Capacity expansion of LSF-SMT stamping tools

1. General Overview

2. Technical changes

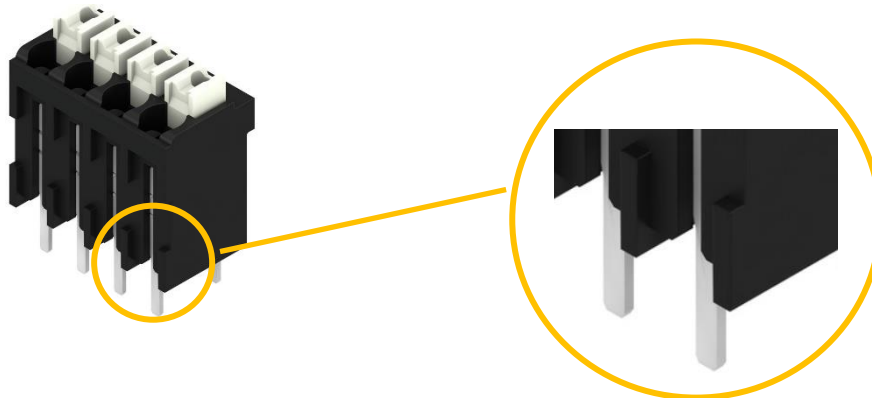
The LSF-SMT solder pins with 3.5 mm solder pin length in tube packaging are changed from fully tinned to pre-tinned solder pins with edge embossing.
